REGULATORY INFORMATION DISTRIBUTION SYSTEM (RIDS)

SUBJECT: Forwards responses re main steam line break reanalysis,per
880301 commitment.

Subject: Palo Verde Nuclear Generating Station (PVNGS)
Units 1, 2 and 3
ANPP Responses to NRC Main Steam Line Break Questions
File: 88-A-056-026

ANPP RESPONSES TO NRC MAIN STEAM LINE
BREAK QUESTIONS

FIGURE 8 REACTIVITY CHANGES

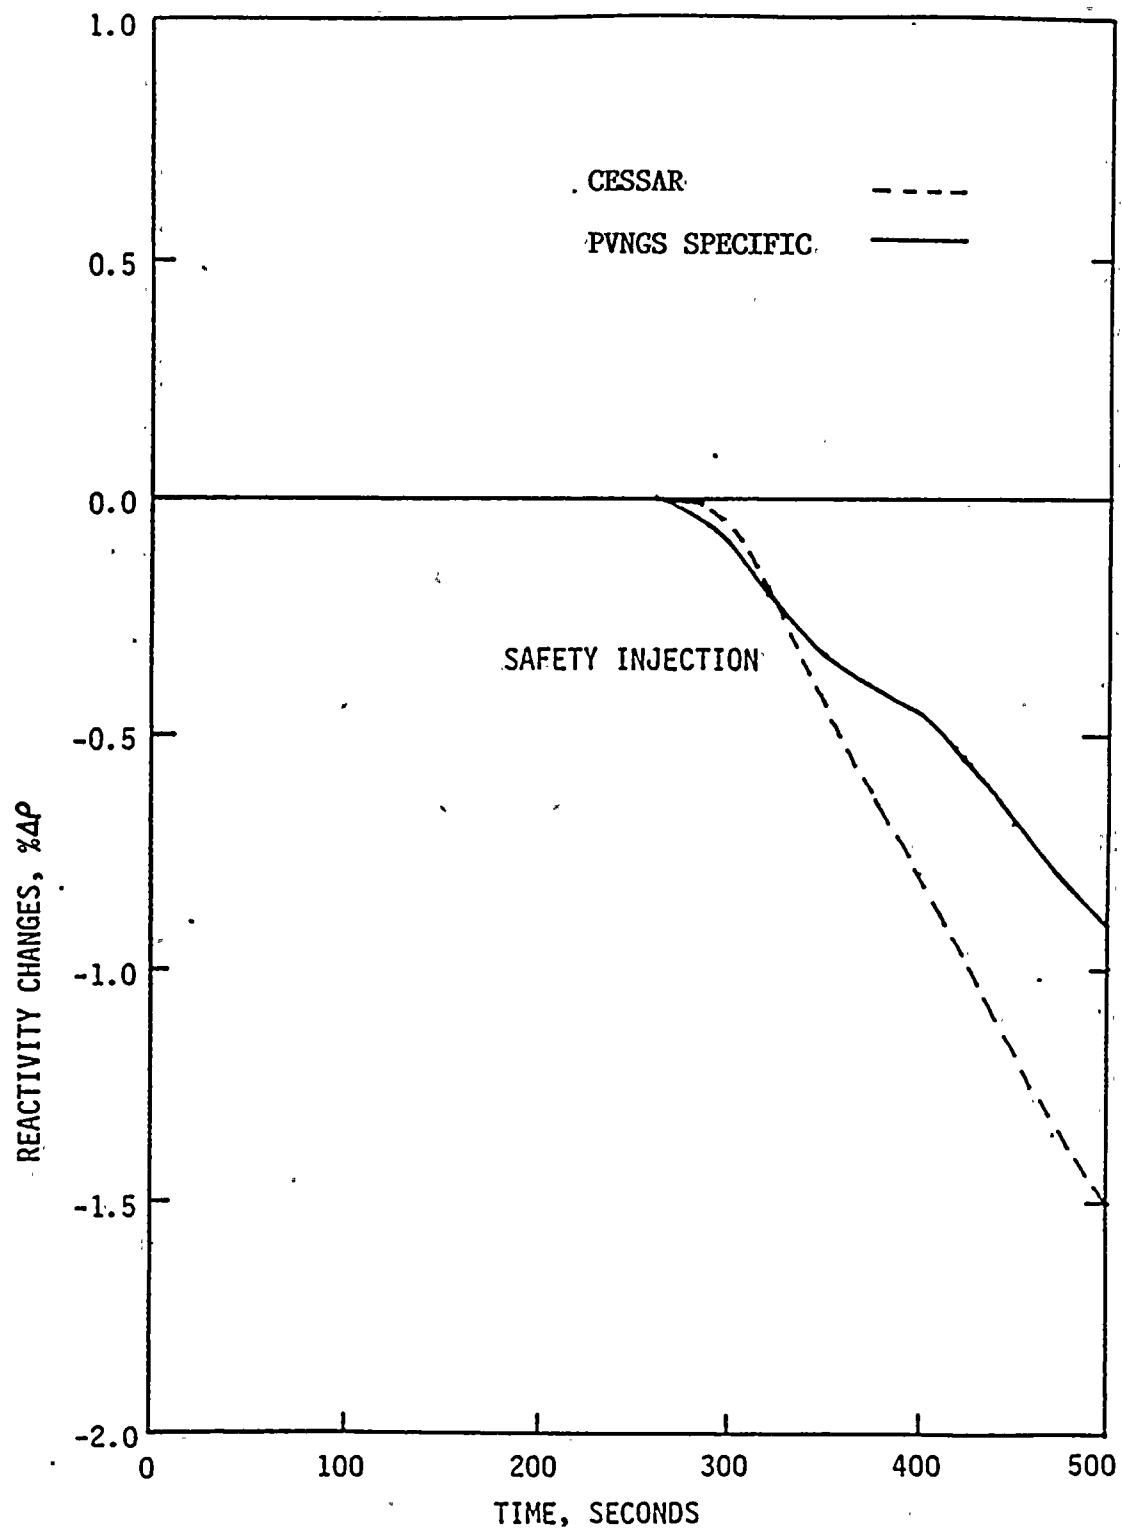
Examination of the changes in Figures 15.1.1.7 indicates a reduction in the negative reactivity insertion accompanying safety injection at a rate causing a change of slope of roughly 1/3. However, changes in Figure 15.1.1.15 indicate that the safety injection flowrate, although varying, is roughly 50% lower in the new computation at, for example, 400 seconds than it was in the original computation, indicating that the new computation may use a higher boron concentration. Explain this result and its connection with the boron transport model changes discussed in Question 2.

Although the safety injection flow rate decreased by approximately 1/3 at 400 seconds, the rate of the negative reactivity insertion by the safety injection flow decreased by roughly 2/3 (from $-0.75\% \Delta \rho / \text{sec}$ to $-0.28\% \Delta \rho / \text{sec}$) at 400 seconds (Figure 8). This decrease is due to the combined effect of the modified RVUH model (see response to Question #3) and the modified safety injection model discussed in Question #2. The previous analysis used an input boron concentration value of 4000 ppm after the safety injection flow swept out the water volume between the RCS cold legs and the first check valves away from the RCS cold legs. For the reanalysis, boron concentrations of 0, 2000, and 4000 ppm were used for the volumes between the cold leg and the Refueling Water Tank (RWT) return line, between the RWT return line and the second check valve, and upstream of the second check valve, respectively (as shown in Figure 5).

At 400 seconds into the transient, the safety injection flow had not swept out the volume downstream of the second check valve. Therefore, at 400 seconds, the safety injection flow boron concentration was 2000 ppm compared to the 4000 ppm used in the previous analysis.

In summary, the decrease of the negative reactivity insertion rate is due to the combined effect of the reduced HPSI delivery curve, the higher RCS pressure predicted by the modified RVUH model, and the conservative (lower) boron concentration used in the modified safety injection model discussed previously.
